Clinton Power Station

Subject: Clinton Power Station Exemption Request and Proposed Amendment to Facility Operating License No. NPF-62 (LA-00-011)

PROPOSED CHANGES TO THE CPS TECHNICAL SPECIFICATIONS

Figure 3.4.11-1
Bottom Head and RCS Composite P/T Curves
for Pressure Tests [Curve A] up to 32 EPFY

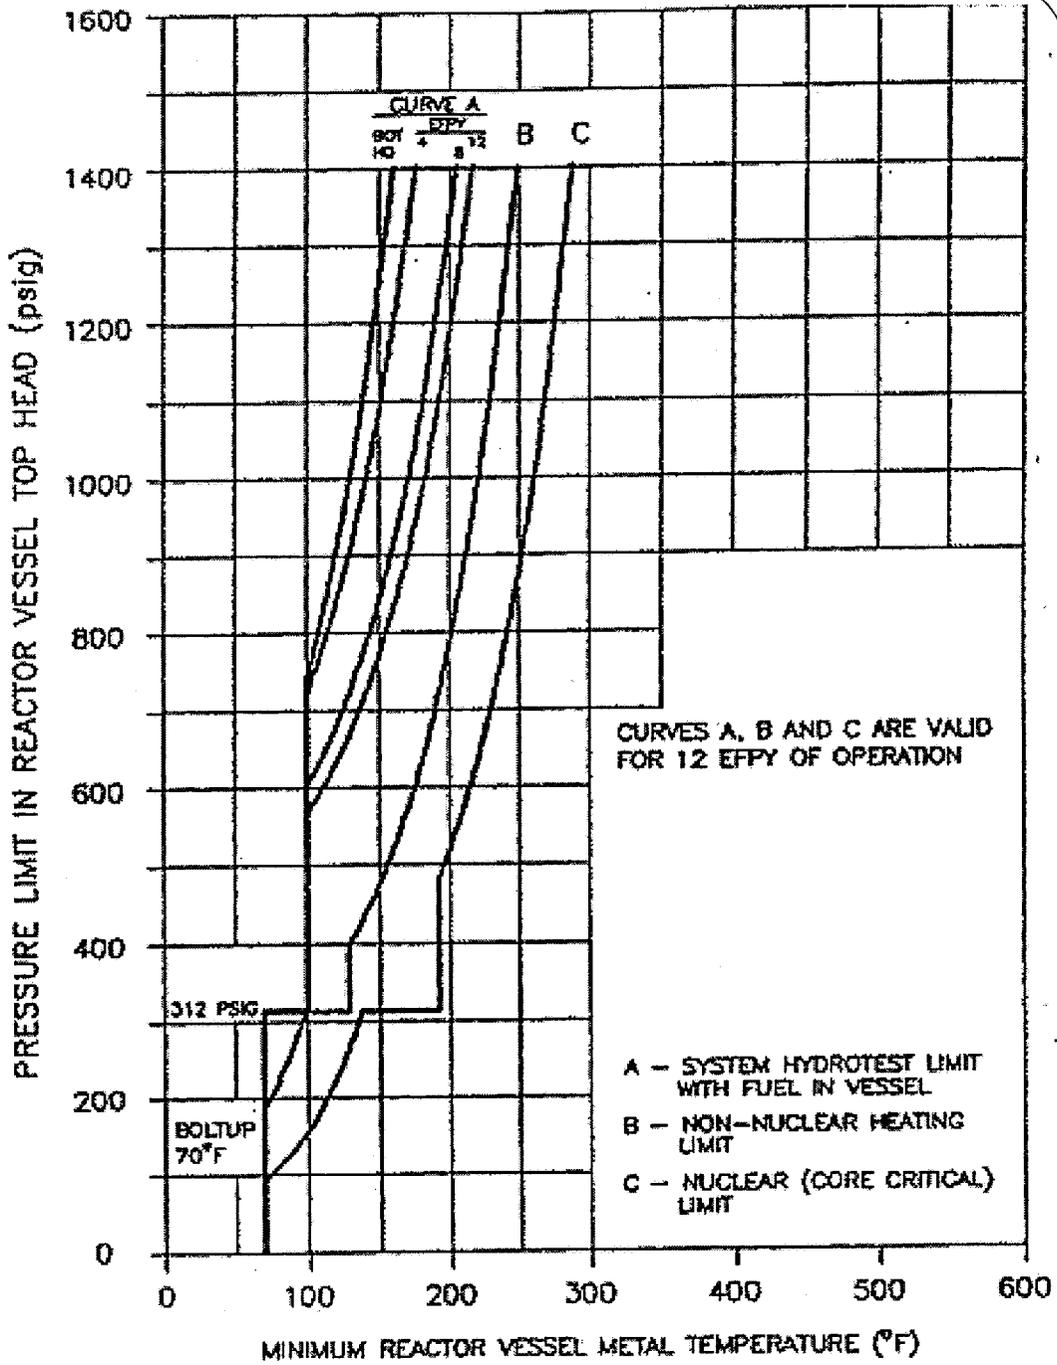
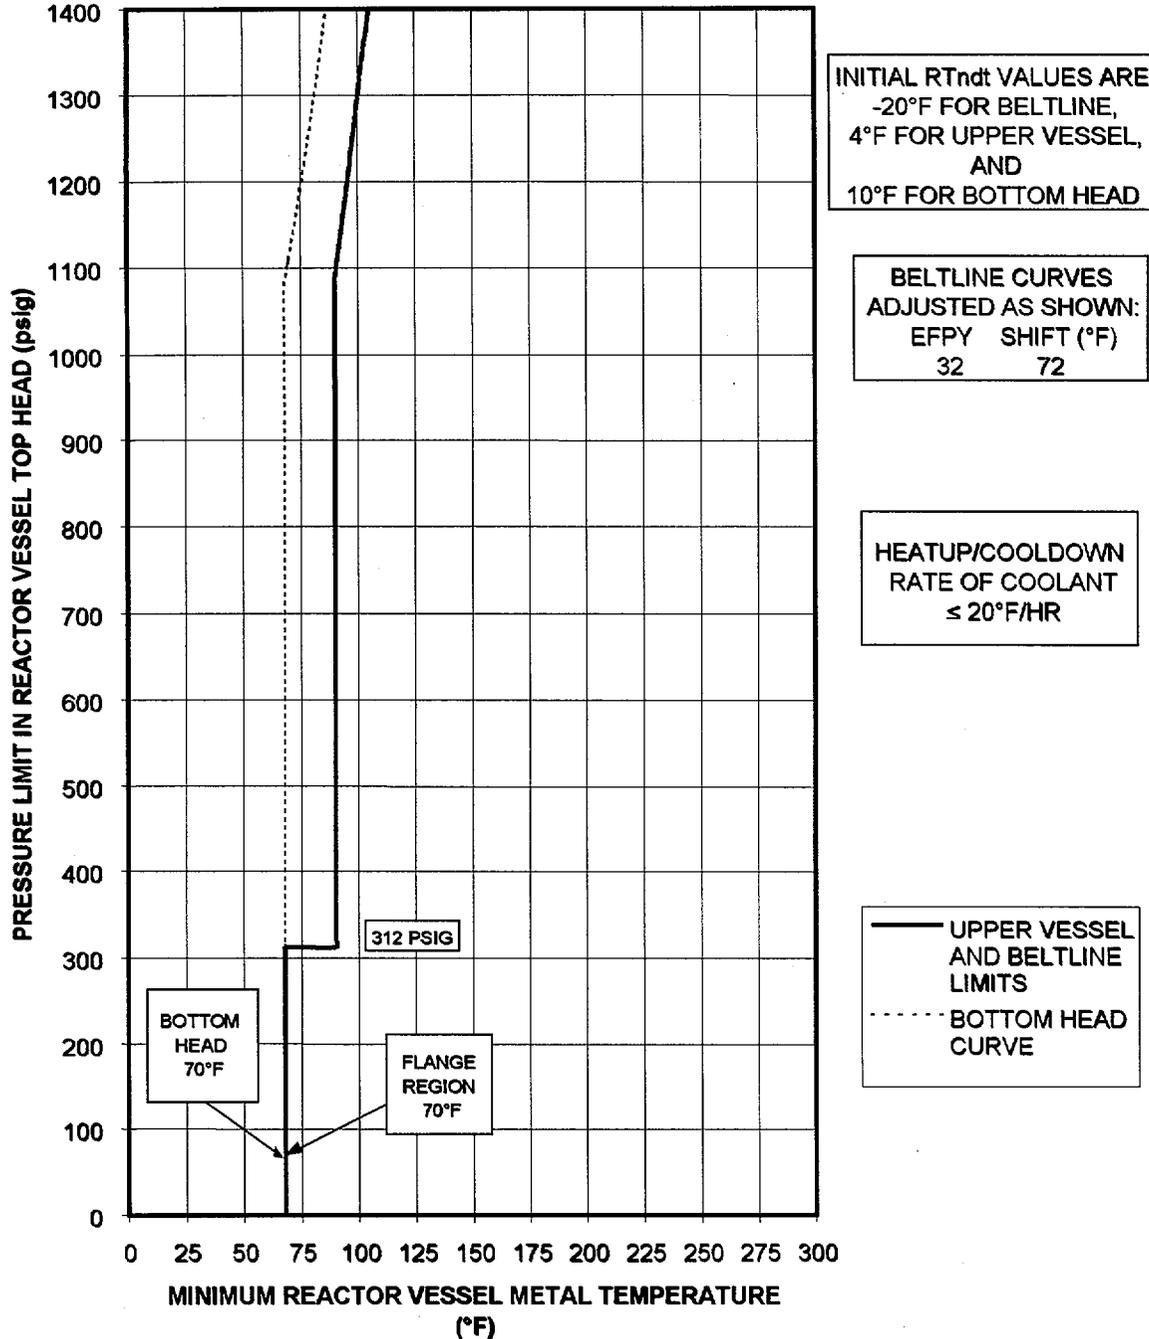
Attachment 3 indicates the proposed administrative changes to TS 3.4.11 and the replacement of Figure 3.4.11-1 with three figures:

- Figure 3.4.11-1, "Bottom Head and Composite P/T Curves For Pressure Tests [Curve A] Up to 32 EFPY,"
- Figure 3.4.11-2, "Bottom Head and Composite P/T Curves for Core Not Critical Operation [Curve B] Up to 32 EFPY," and
- Figure 3.4.11-3, "Composite P/T Curves for Core Critical Operation [Curve C] Up to 32 EFPY."

The current pressure-temperature (P-T or P/T) limits specified per Figure 3.4.11-1 are indicated via several curves on a single figure, for the various operating and/or test conditions. The current curves are to be replaced with recalculated curves on separate figures, and the associated descriptions contained on the figures are to be revised as well. Revised TS Figure 3.4.11-1 will have a curve for the bottom head region of the vessel and a composite RCS curve (excluding the bottom head) for hydrostatic testing and leak testing conditions for an exposure level up to 32 effective full power years (EFPY). Figure 3.4.11-2 will have a curve for the bottom head region of the vessel and the composite RCS curve (excluding the bottom head) for non-critical operation for up to 32 EFPY. Figure 3.4.11-3 will have a curve for the entire RCS for reactor critical operation for up to 32 EFPY. These curves for specifying the required temperature limits will continue to ensure margin to the brittle fracture temperature, i.e., the nil ductility temperature, for the noted operations or conditions. One of the primary effects of the revised curves is to permit reactor vessel inservice hydrostatic and leak tests to be performed at a lower temperature at applicable vessel pressures.
